Farkantex Ltd.(New Shed)

SECTOR # 5(A), PLOT #1&2, C.E.P.Z , CHATTOGRAM-4223

26th September 2019

Observations

Dining Shed

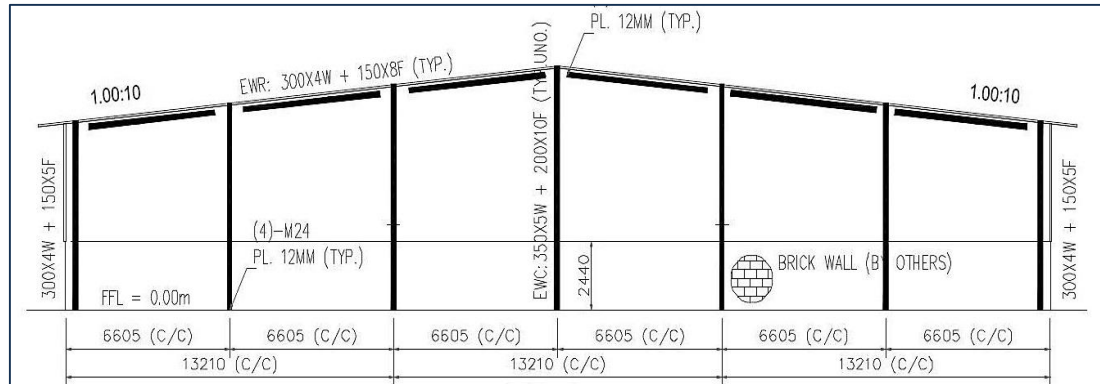
Apparently non-engineered Dining shed. Factory engineer is required to replace the shed with an engineered shed.
